Re: Initial Submission Review – Queen of Peace Catholic Parish – Site Plan Amendment
Application Number: **DA-1165-03**
Case Number: **1988-6042-06**

Initial Submission Review

MAJOR SITE PLAN AMENDMENT

SHEET NUMBER:
4 OF 8

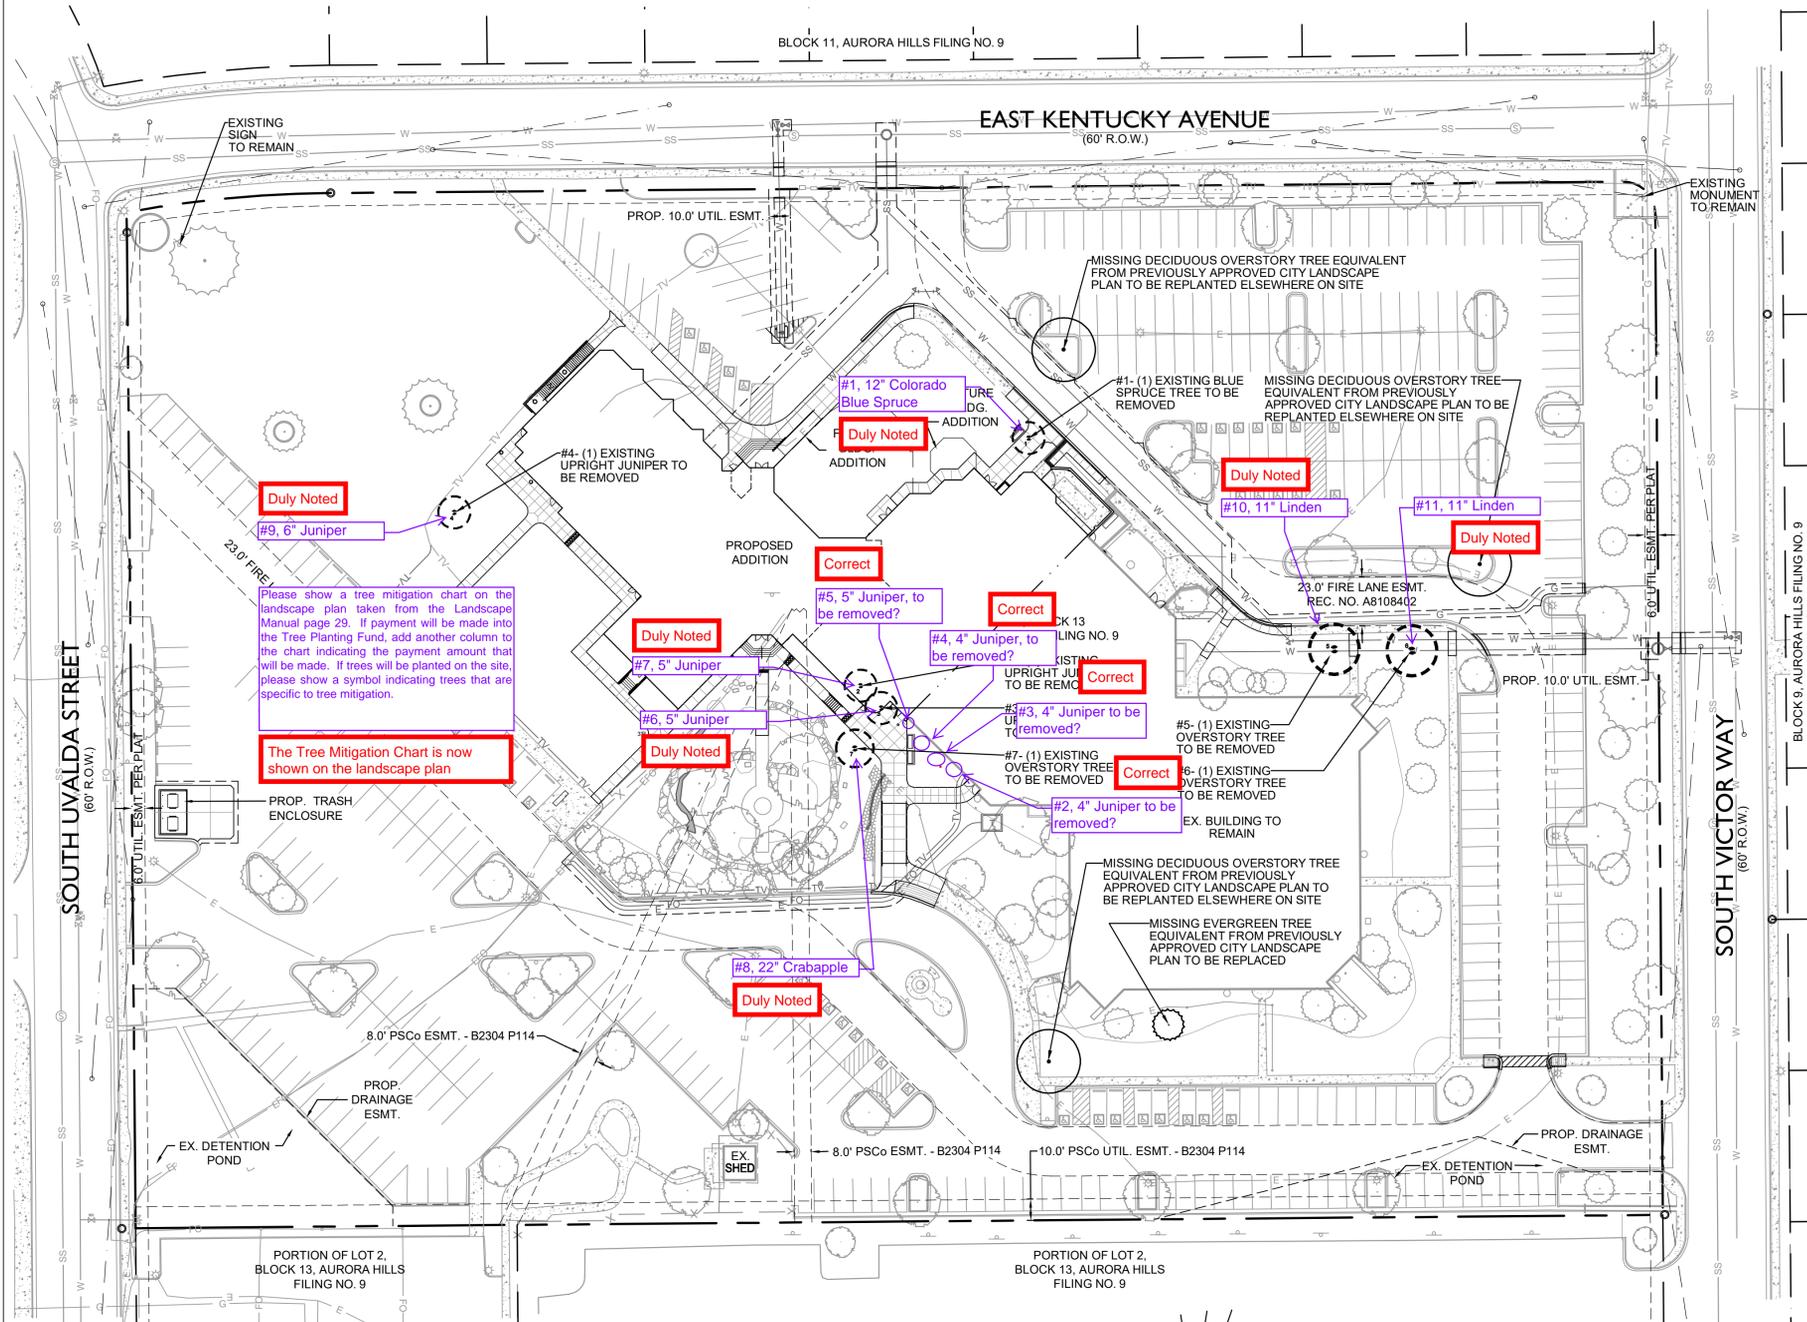
- Relocate the fire hydrant and waterline to new proposed location adjacent to fire lane. **RESPONSE: Hydrant has been relocated as coordinated separately with COA.**

- Any dead-end water line supplying a fire hydrant that exceeding 150 ft. is required to provide a calculation within the Utility Sheet of the Civil Plans to validate the 20-psi minimum residual water pressure needed. **RESPONSE: Relocated dead-end water line supplying hydrant is less than 150 ft.**

- Identify Fire Line using the following example: "6" Fire Line DIP (Private)." **RESPONSE: Labels have been update per comment.**
- Show location of Riser Room and exterior door for each fire sprinklered building. **RESPONSE: Riser Room is shown on the plans.**

10A. Special tapping saddle may be required with ACP pipe. **RESPONSE: To be addressed on Civil Construction Plans.**

10B. Provide fixture unit table at the time of submitting Civil Drawings to justify meter size for both new and existing fixtures. **RESPONSE: To be addressed on Civil Construction Plans.**

SHEET TITLE:
TREE PROTECTION AND MITIGATION PLAN
 SHEET NUMBER:
5 OF 8

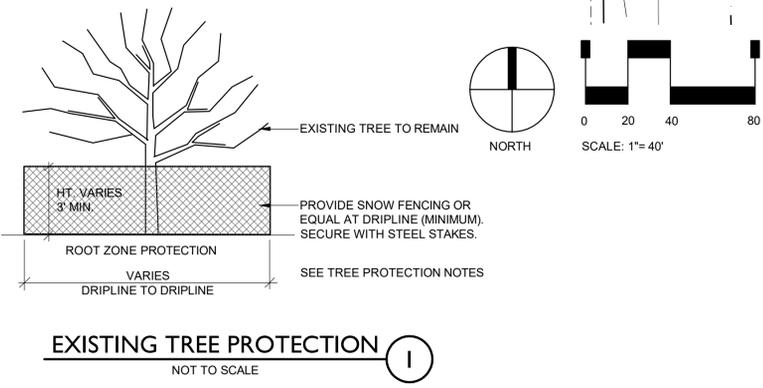
12B. See site plan page 5 of 8 as there are several Juniper trees located on the south side of the building located next to Juniper #2 and #3 and very close to construction. Please clarify whether or not these trees will be removed or preserved. **RESPONSE: These Junipers are to be removed.**

Please show a tree mitigation chart on the landscape plan taken from the Landscape Manual page 29. If payment will be made into the Tree Planting Fund, add another column to the chart indicating the payment amount that will be made. If trees will be planted on the site, please show a symbol indicating trees that are specific to tree mitigation. **RESPONSE: The Tree Mitigation Chart is now shown on the landscape plan.**

SHEET NUMBER:
6 OF 8

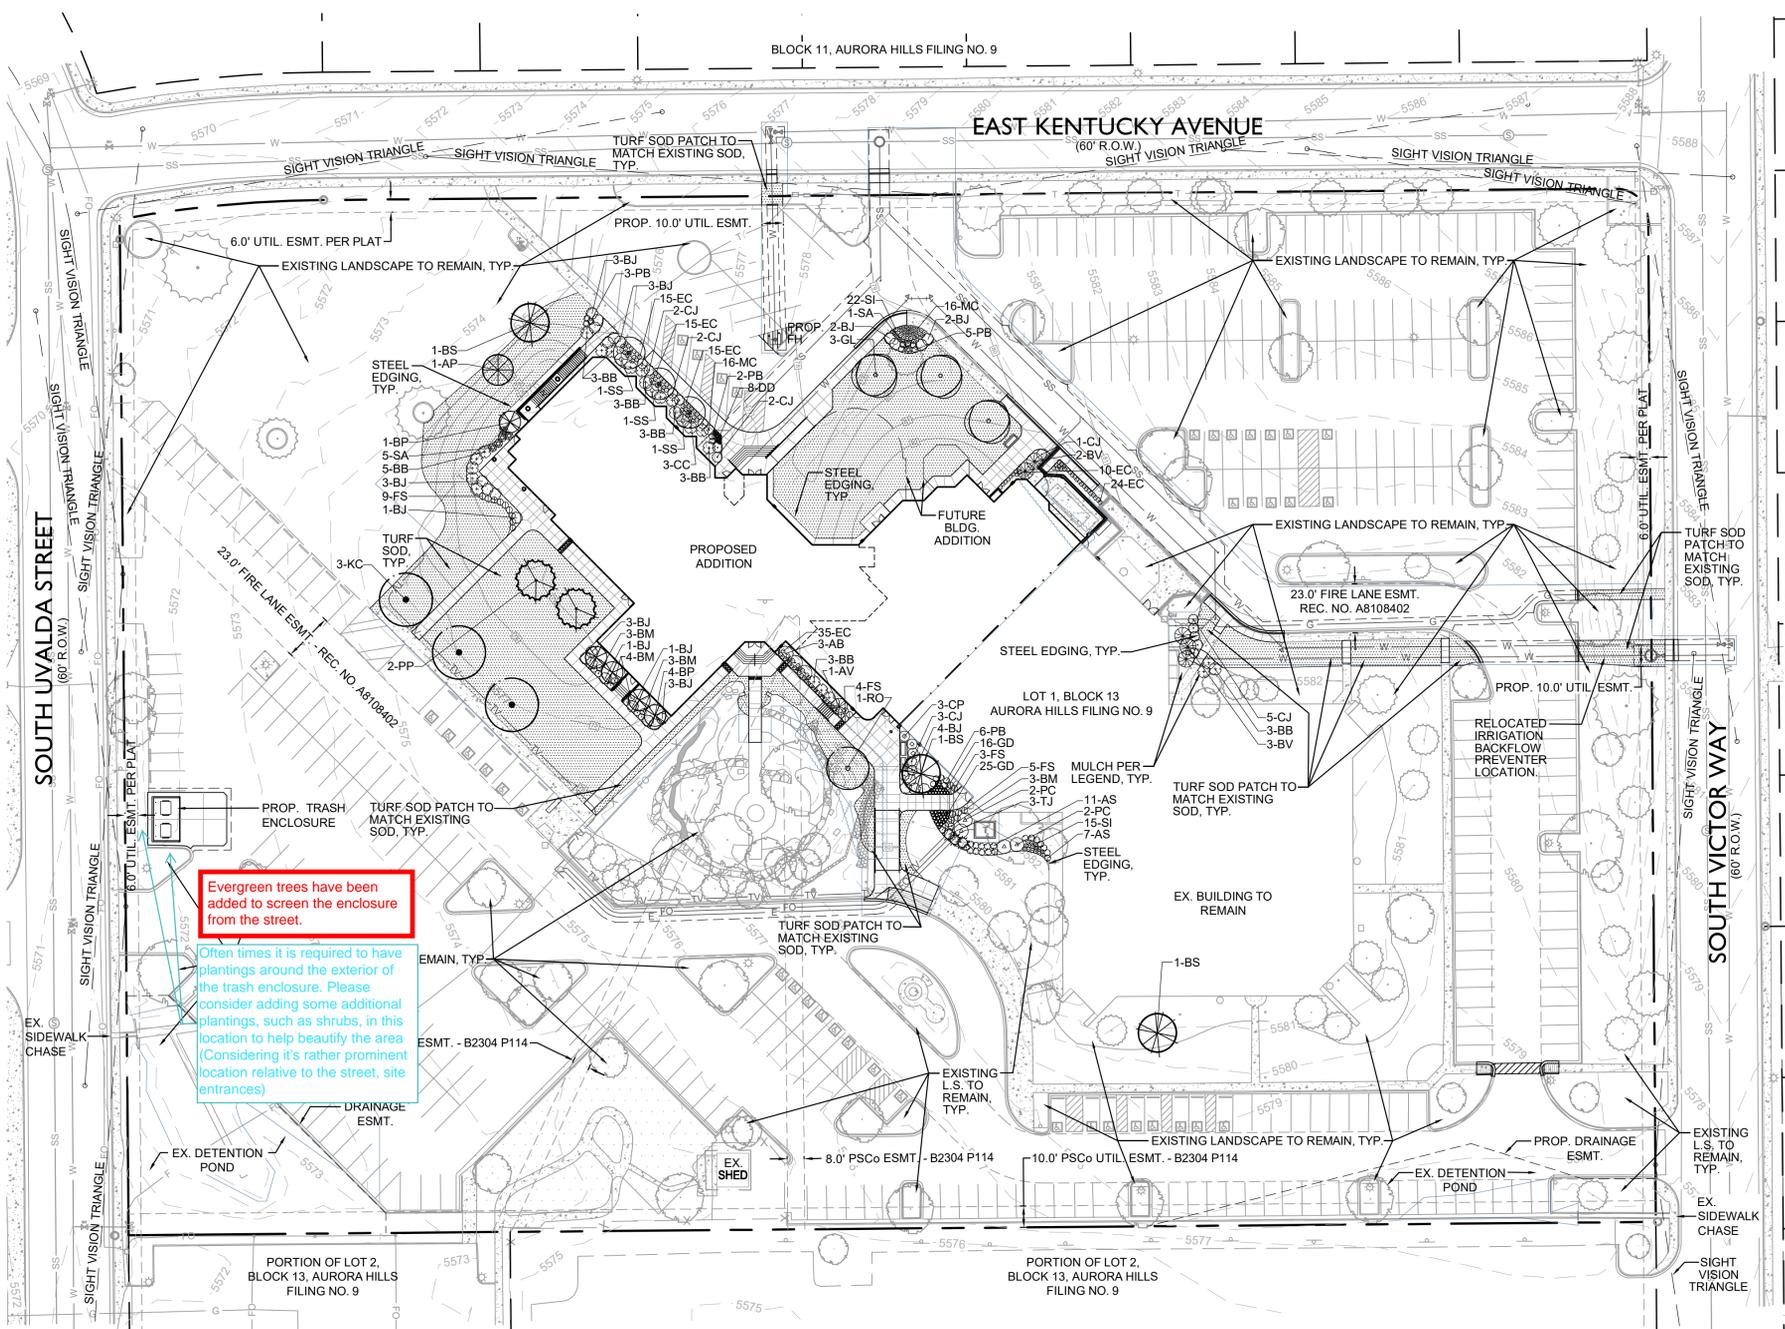
- Update the required minimum tree sizes to 2.5” for deciduous canopy trees and 2” for ornamental. **RESPONSE: Tree Sizes have been revised.**

Update sight triangles per comments on Site Plan.

Often times it is required to have plantings around the exterior of the trash enclosure. Please consider adding some additional plantings, such as shrubs, in this location to help beautify the area (Considering it's rather prominent location relative to the street, site entrances)

Sight Triangle's have been revised

Evergreen trees have been added to screen the enclosure from the street.

SHEET NUMBER:
7 OF 8

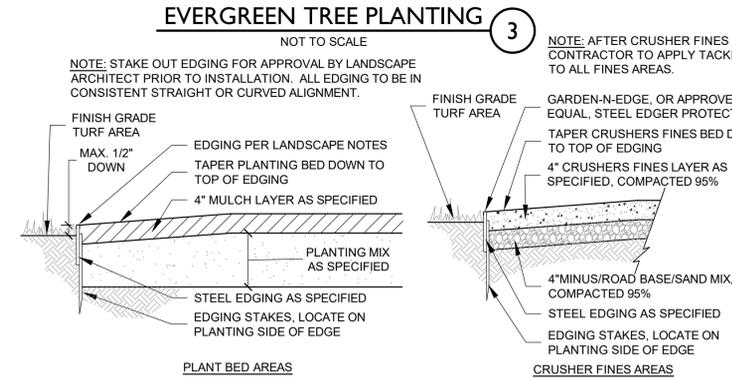
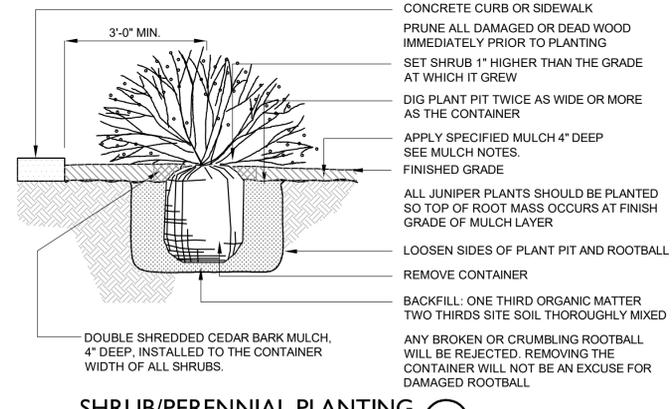
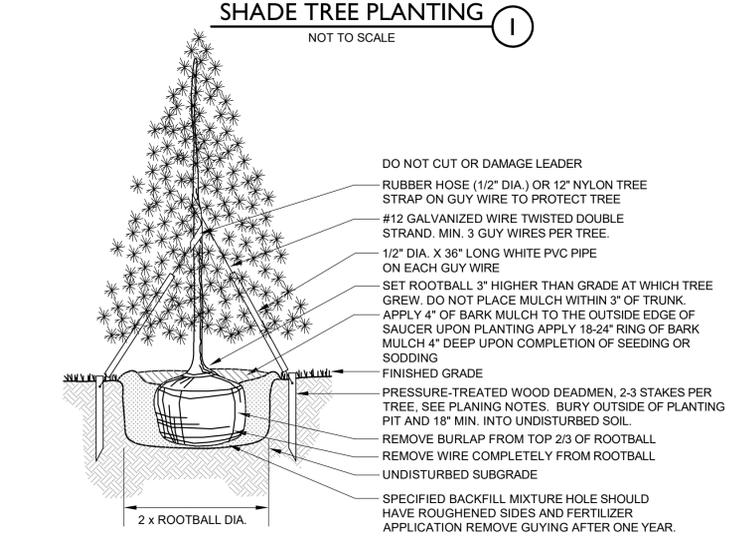
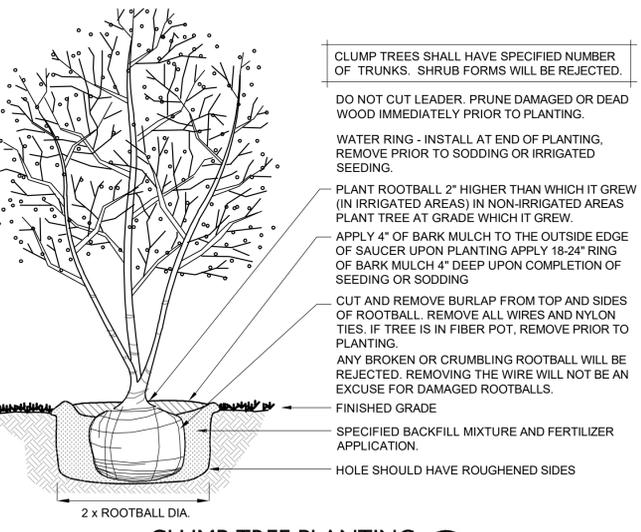
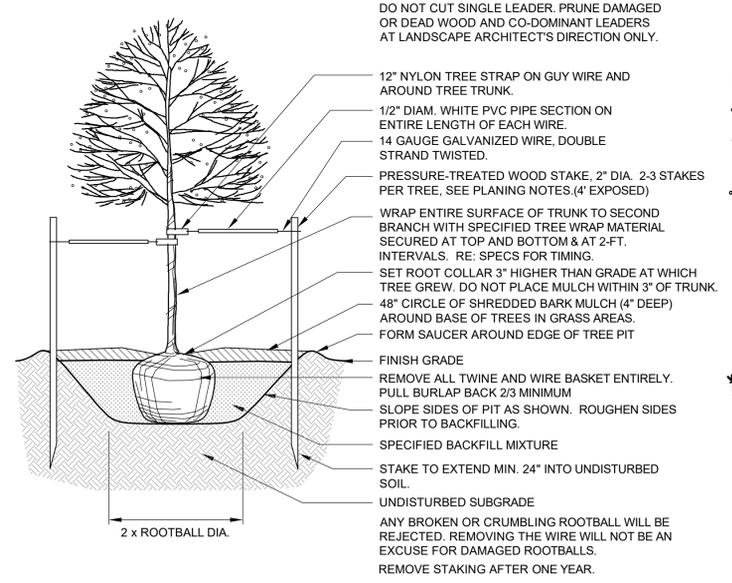
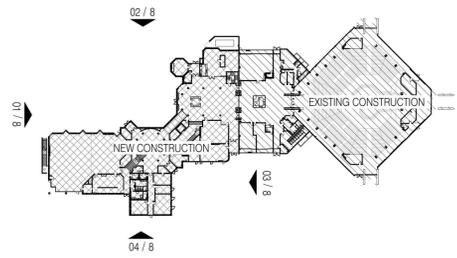
- Remove the landscape specifications. The landscape plans should only include the required landscape notes and any notes dealing with proposed mulches and edger. **RESPONSE: Landscape notes have been revised.**

Provide a detail for site furniture

Please add this landscape note:
THE LANDSCAPE PLAN MUST REFLECT THE LOCATION OF ALL FIRE HYDRANTS, KNOX HARDWARE AND FIRE DEPARTMENT CONNECTIONS TO ENSURE THAT THESE DEVICES ARE NOT PHYSICALLY OR VISUALLY OBSTRUCTED FROM RESPONDING FIRE CREWS. THE SEPARATION REQUIREMENTS FROM FIRE DEPARTMENT CONNECTIONS AND FIRE HYDRANTS MUST MEET BOTH LIFE SAFETY (TYPICALLY 5 FEET AND NO MATERIAL GREATER THAN 2 FEET IN HEIGHT) AND LANDSCAPING REQUIREMENTS. LANDSCAPING MATERIAL CANNOT BE OMITTED OR REDUCED BASED ON THE INSTALLATION OF A FIRE HYDRANT WITHIN A PARKING LOT ISLAND OR PLANT BED. IT IS RECOMMENDED THAT THE ISLAND OR PLANT BED BE CONSTRUCTED LARGE ENOUGH TO ADEQUATELY ACCOMMODATE BOTH LANDSCAPING MATERIAL AND FIRE HYDRANTS IN ORDER TO COMPLY WITH ALL CITY STANDARDS.

Please remove specifications. Only include the standard required landscape notes.

This detail has been added to this sheet.

This note has been added to this sheet

Landscape notes have been revised

01 ELEVATION - NORTHWEST
 1/16" = 1'-0"

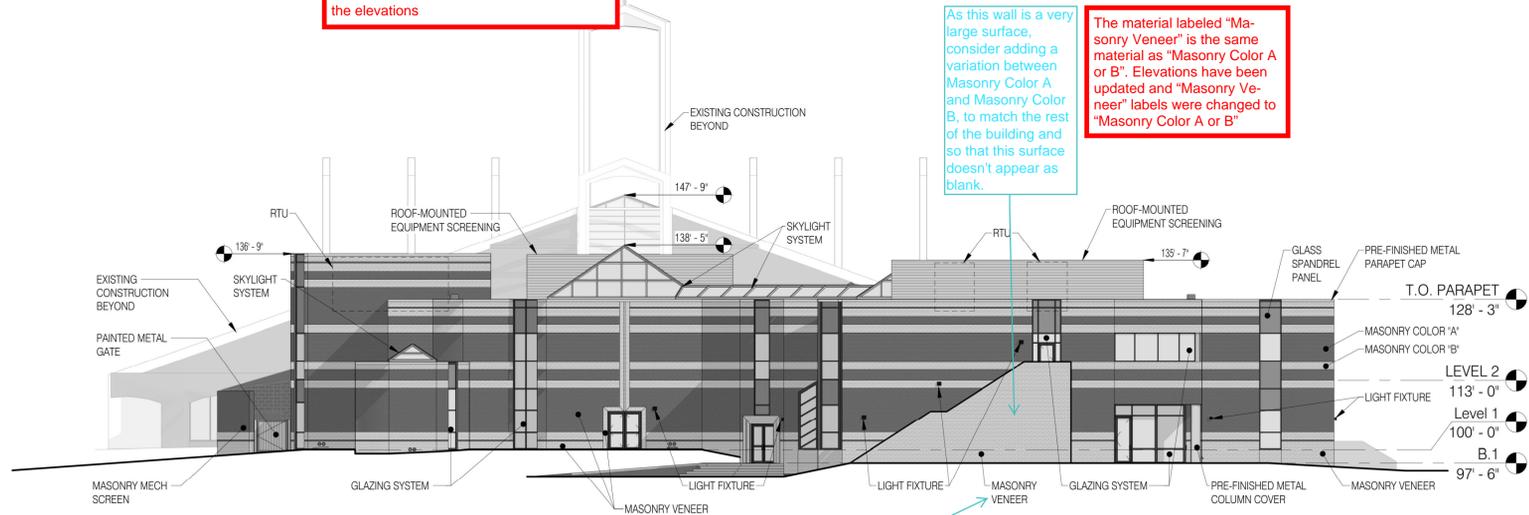
4A. Please clarify what material type the “Masonry Veneer” label is representing throughout the building elevations. **RESPONSE: The material labeled “Masonry Veneer” is the same material as “Masonry Color A or B”. Elevations have been updated and “Masonry Veneer” labels were changed to “Masonry Color A or B”.**

4B. The side of the stairway on the Northwest building elevation presents a large, blank surface. Please add variation between the Masonry Color A and B on this face so that it breaks up the appearance of the stairway and is more consistent with the rest of the building façade. **RESPONSE: The material for the stair on the Northwest building elevation has been revised to be more consistent with the rest of the building façade.**

Identify the FDC as a Y symbol and label with the following example: "FDC with approved Knox Caps."
 Identify the Knox Box as an X within a box symbol and label with the following example: "Knox Box." (Typical for Site, Utility, Elevation and Photometric Plans.)

As this wall is a very large surface, consider adding a variation between Masonry Color A and Masonry Color B, to match the rest of the building and so that this surface doesn't appear as blank.

FDC and Knox Boxes have been added to the elevations

The material labeled "Masonry Veneer" is the same material as "Masonry Color A or B". Elevations have been updated and "Masonry Veneer" labels were changed to "Masonry Color A or B"

The material for the stair on the Northwest building elevation has been revised to be more consistent with the rest of the building facade
